DISPUTE REVIEW BOARD RECOMMENDATION

RE: FIN: 256338-1-52-01
SPN: 14570-3519
Contract No.: 21198
County: Pasco
District: Seven
SR-54 from SR 55 (US-19) to East of Madison St.

Whether or not the fiberglass structure in Pond 1A as depicted on Sheet 188 should have been included in Pay Item 2425-2-72 and whether the Contractor is entitled to additional/separate compensation for the Pond No. 1A Skimmers beyond what was provided for in the original contract documents.

- Sheet No. 184 of the plans – DRAINAGE STRUCTURE DETAILS – **SKIMMER DETAILS** shows Pond 1A Skimmer Detail;

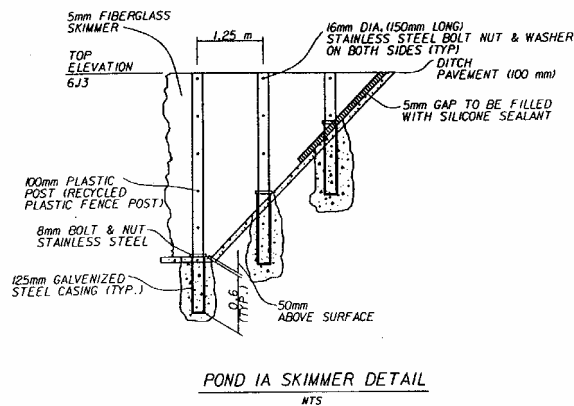
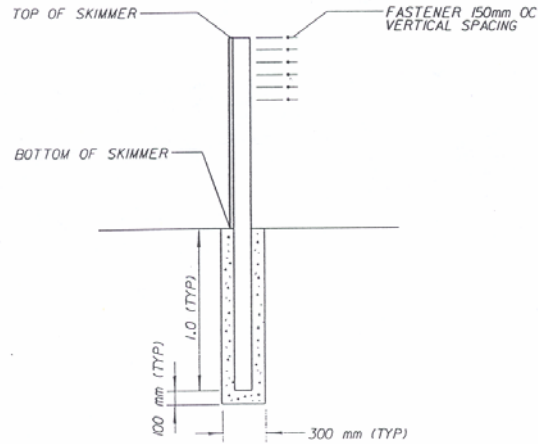
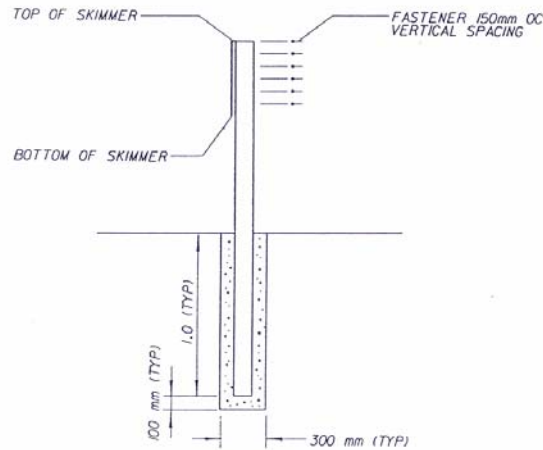
- There is **no note** on sheet 184, similar to the one on sheet 183, or **any other drainage structure detail sheet denoting how “Pond 1A skimmer” is to be paid.**
- Other than the Pay Item Note there is no note associated with payment of the skimmer in question.

- Sheet No. 188 of the plans – POND 1A LAYOUT SHEET shows “CONST. SKIMMER”: at S-300 **and** in the pond:

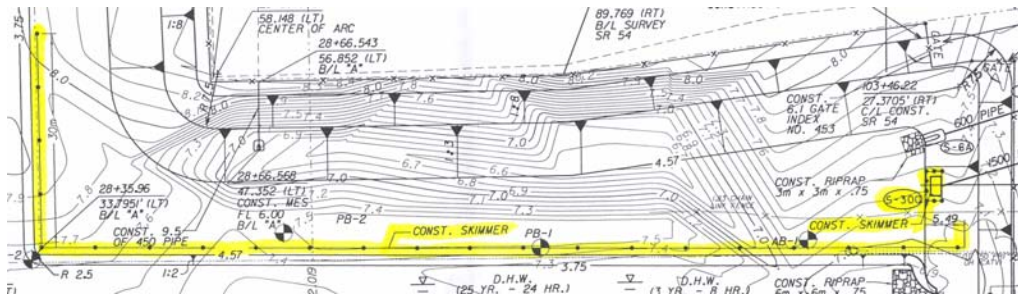
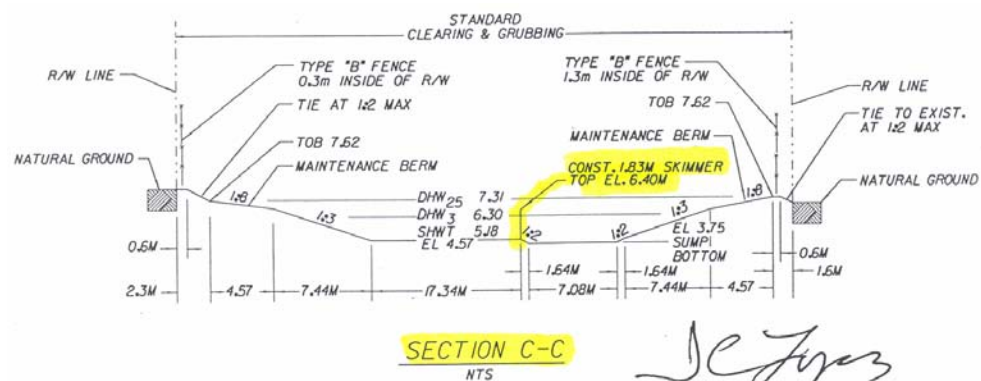
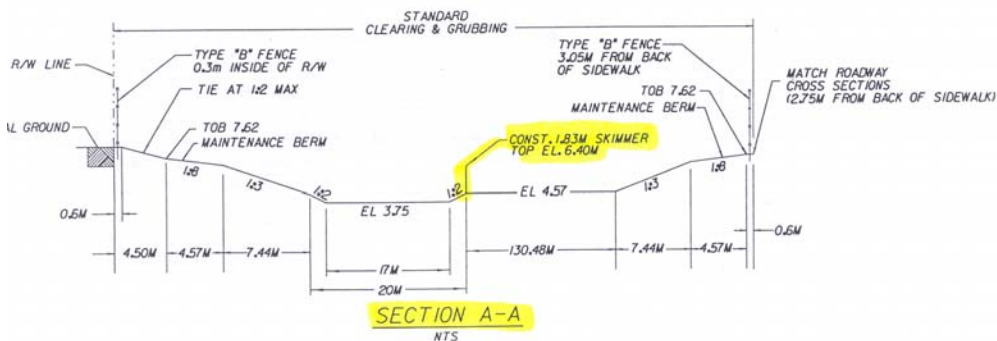
- Clearly **two (2) Skimmers are shown to be constructed in Pond 1A.**
- These are **designated as skimmers** and there are no other skimmers on the project.
- **All/both** skimmers are **shown on the same plan sheets.**
- Sheet No. 189 of the plans – POND 1A shows Section A-A and Section C-C denoting “CONST. 1.82 M **SKIMMER TOP EL. 6.40 M**”: in the pond:
